Cross River Rail project

Coordinator-General's change report – design refinements and condition changes 2020

July 2020

Figure 4.2 Albion overhead lines and signal upgrade worksite (Source: Pre-lodgement Information Sheet 2 of 12)

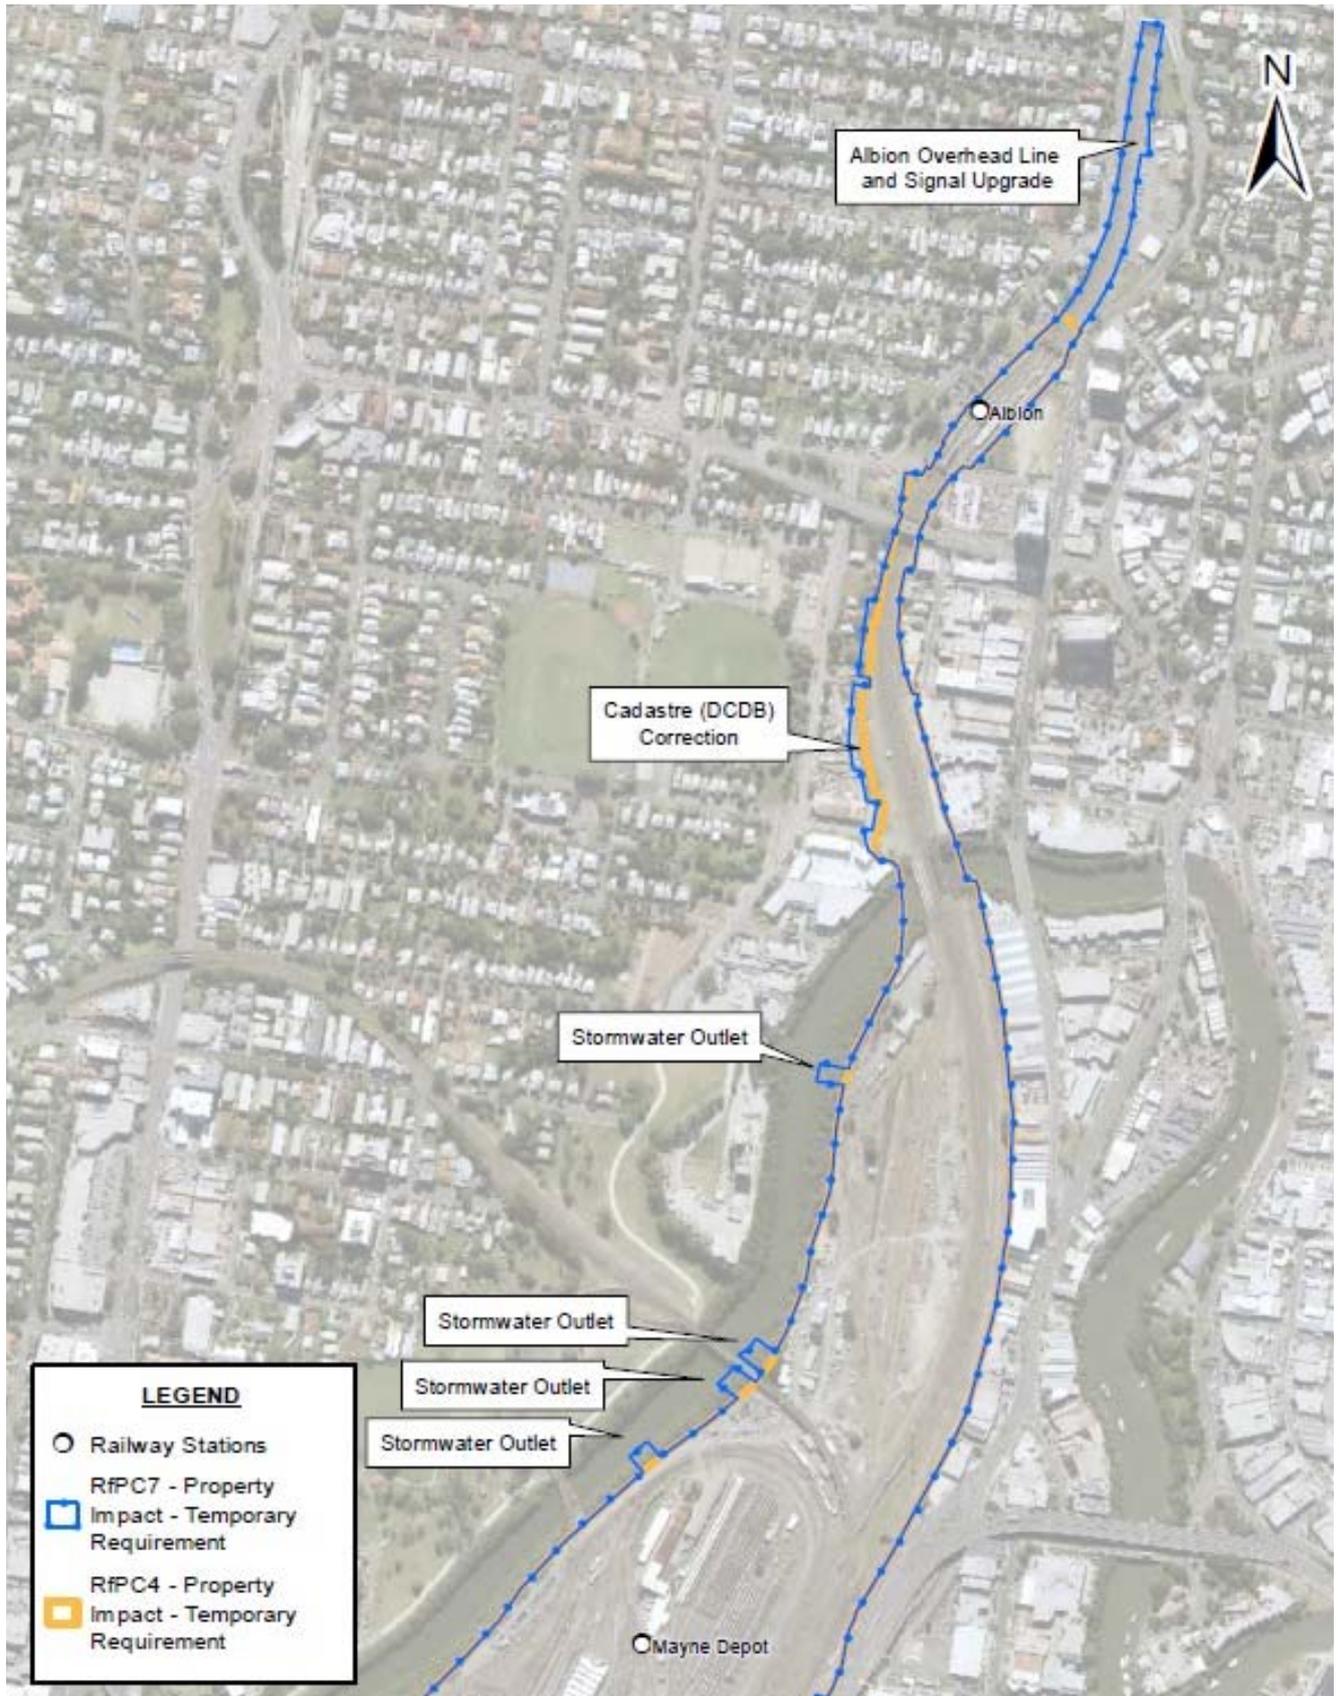
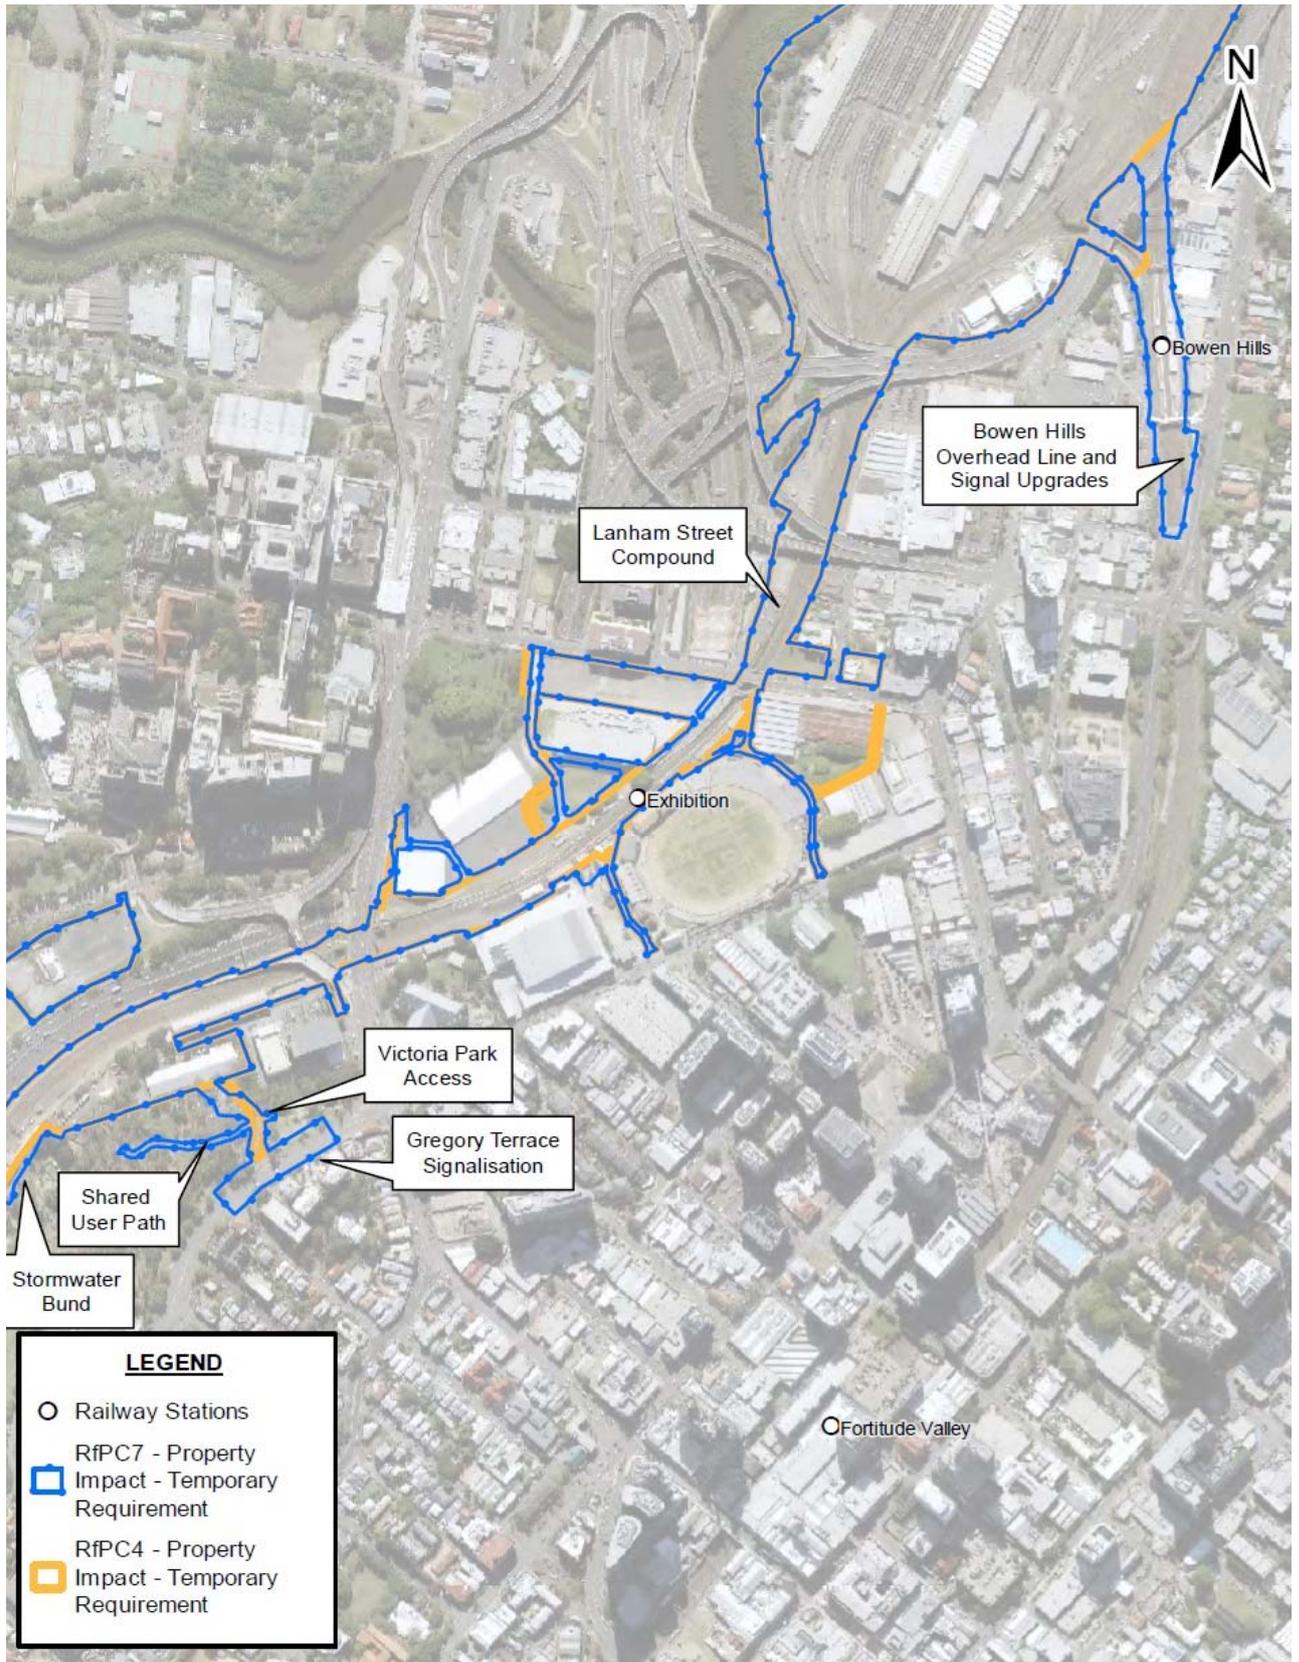
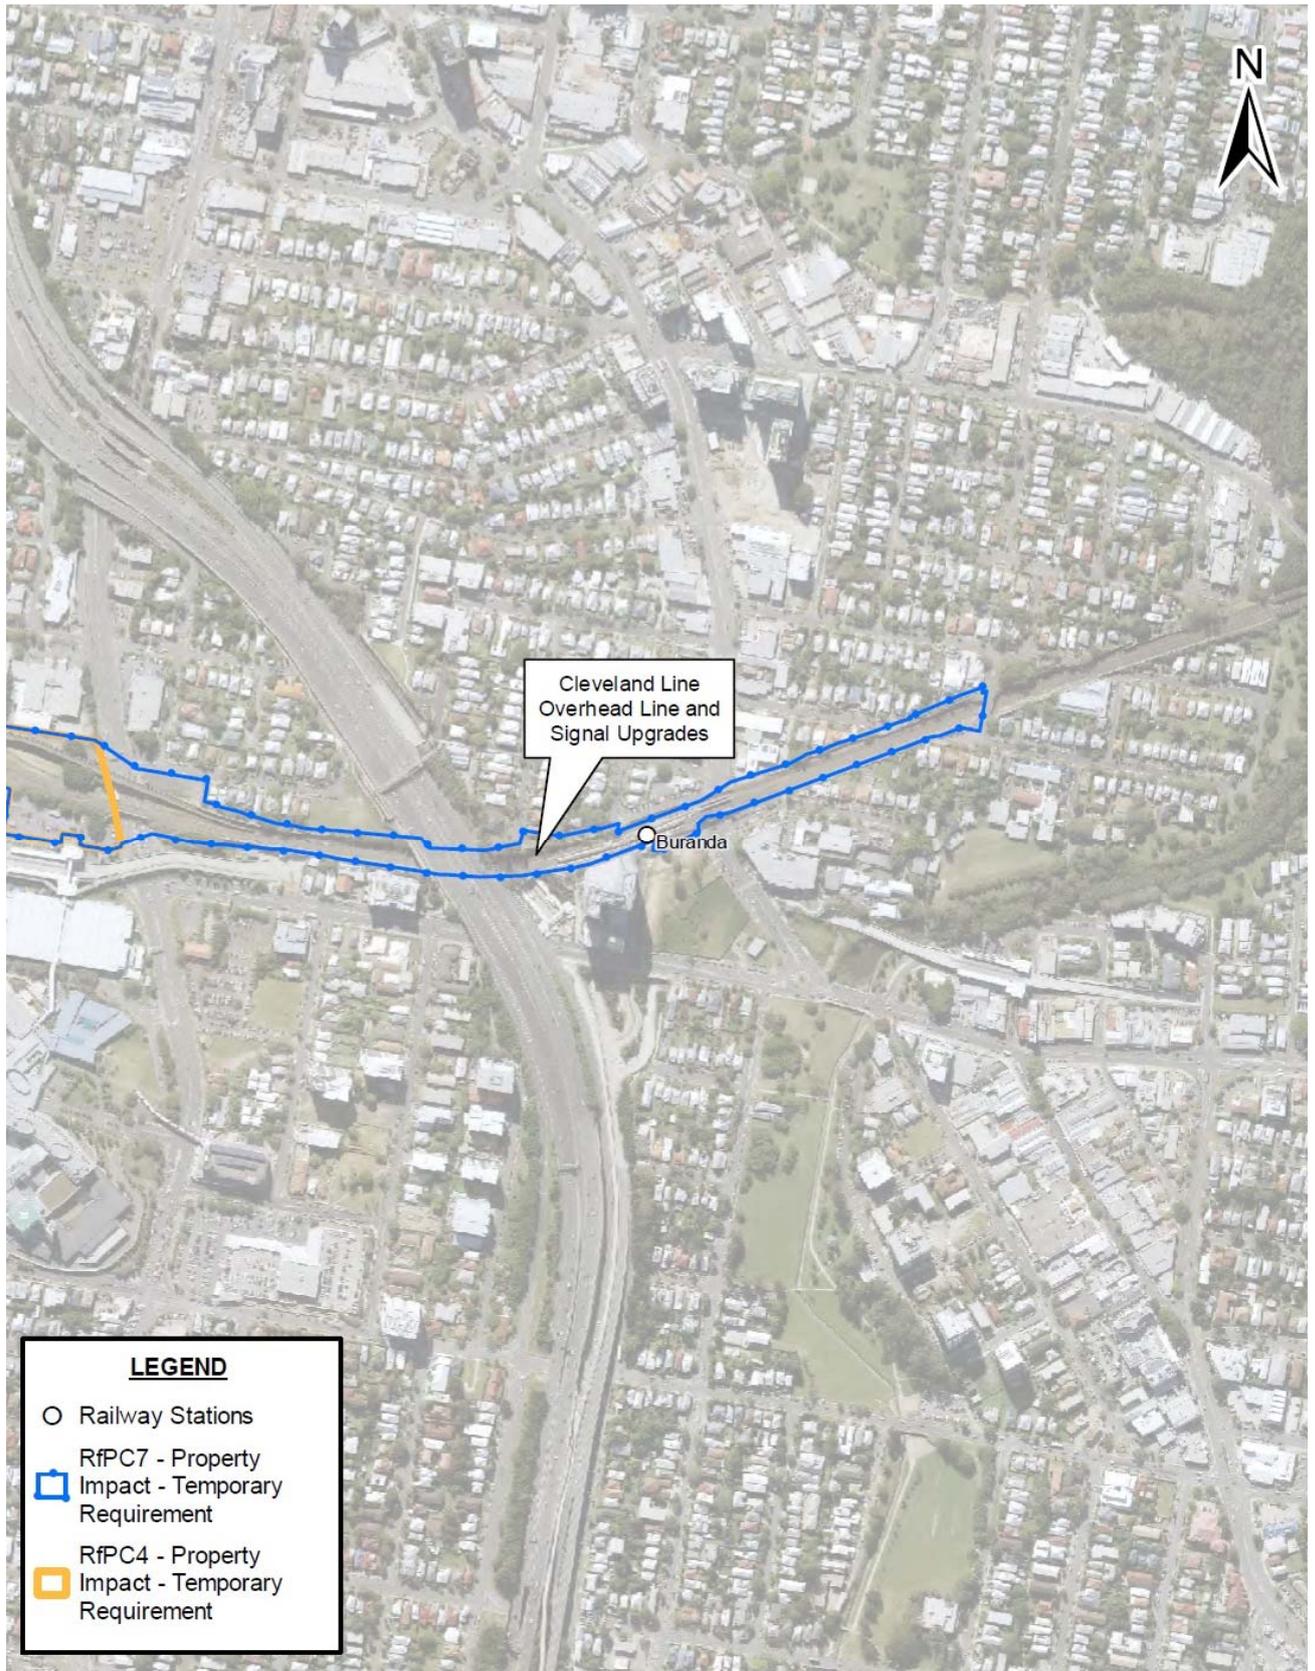
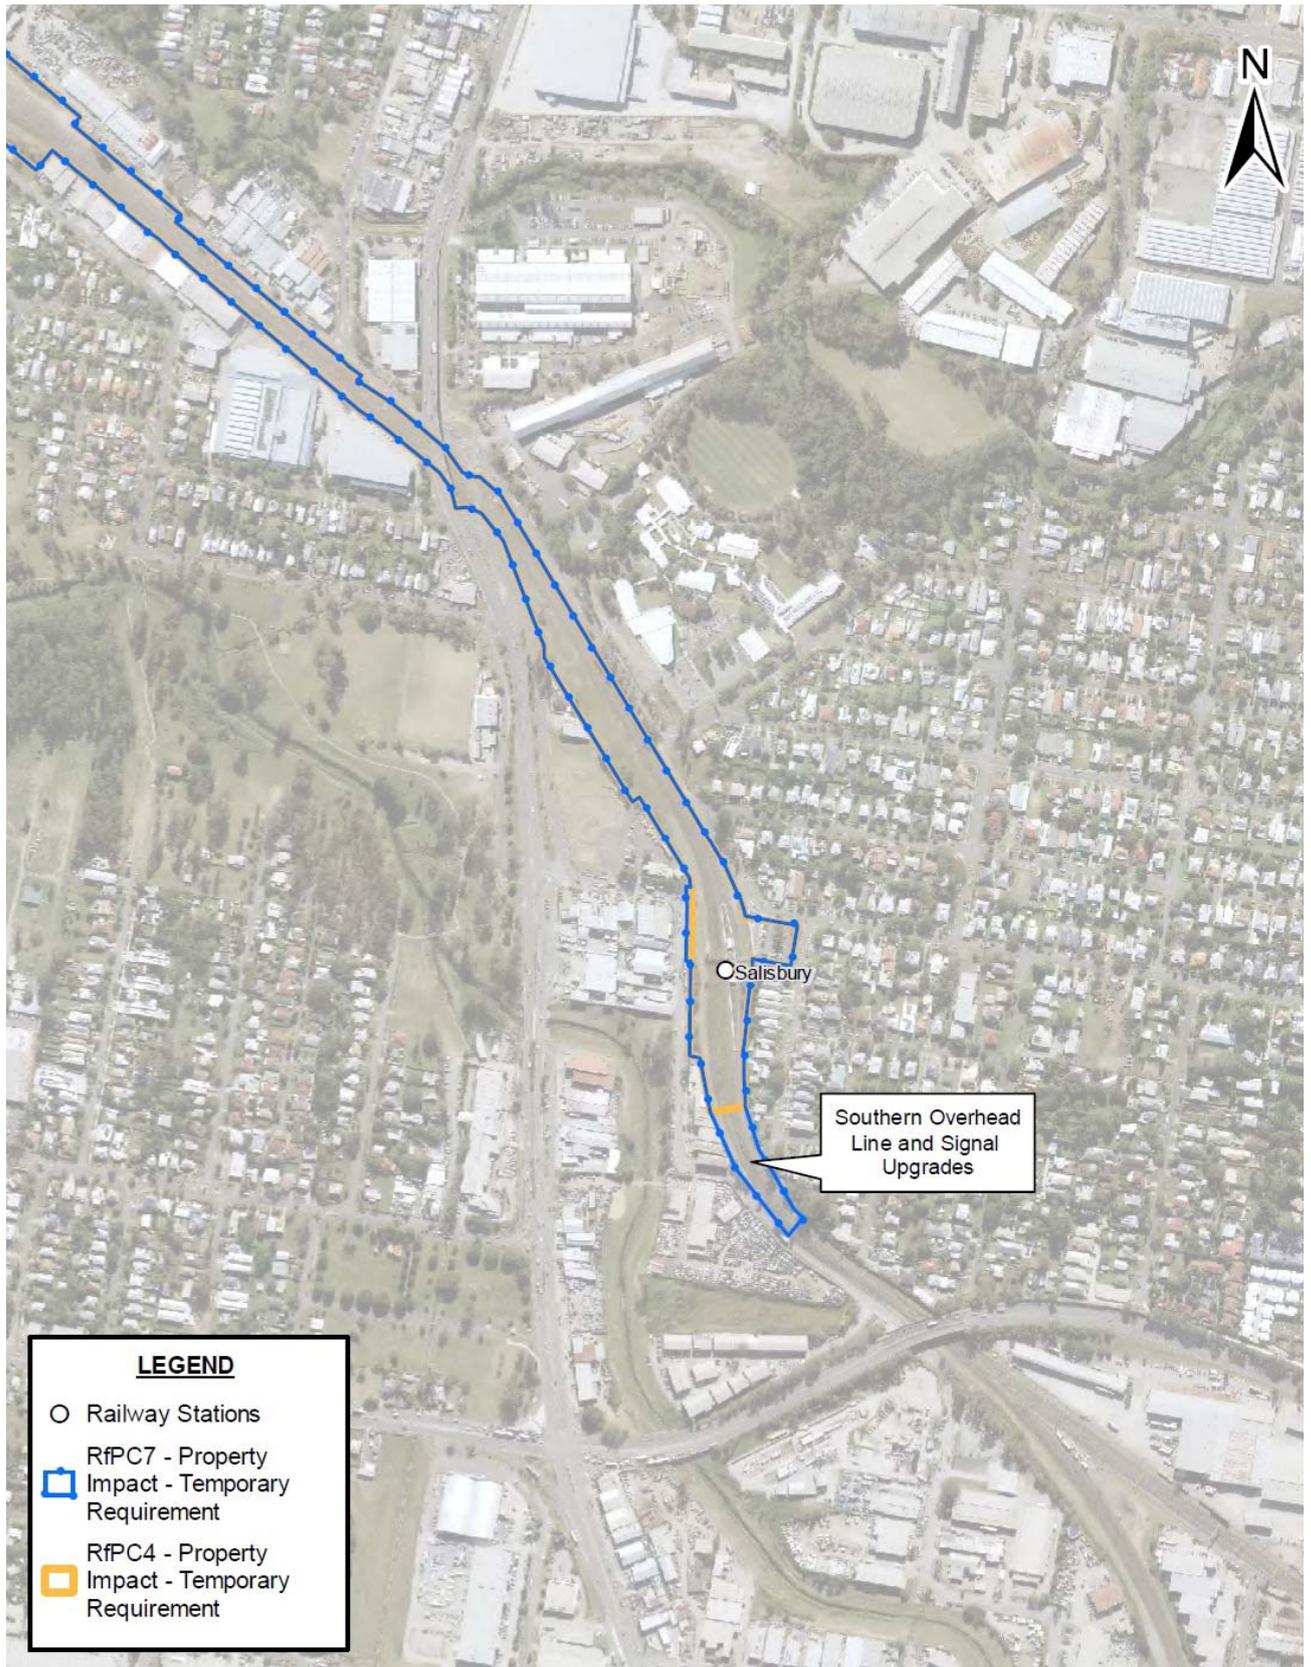
An extension to the project boundaries has been requested to include temporary land requirements for overhead line and signal upgrade works within the rail corridor at Albion station, Bowen Hills station, Cleveland Line (at Buranda), Tennyson Junction, and at the southern end of the project near Salisbury station. These works are required to enable the Cross River Rail project infrastructure to be successfully integrated with the existing QR network. Refer to Figures 4.2 to 4.6 which show the additional temporary land requirements for the overhead lines and signal upgrade works.

The locations identified in the change application for the additional overhead line and signal upgrade works are on new land within the rail corridor that has not been previously assessed as part of the evaluated project or included in the project boundary. The land use surrounding each of the proposed worksites and potential sensitive receptors for the proposed changes are listed in Table 4.1.

Buranda), Tennyson Junction, and at the southern end of the project near Salisbury station. I am satisfied that the project's environmental management framework consisting of the Imposed Conditions, the OEMP and CEMP are sufficient to manage the environmental impacts. I accept the proposed change to temporary land requirements at Albion station, Bowen Hills station, Cleveland Line (at Buranda), Tennyson Junction, and at the southern end of the project near Salisbury station.
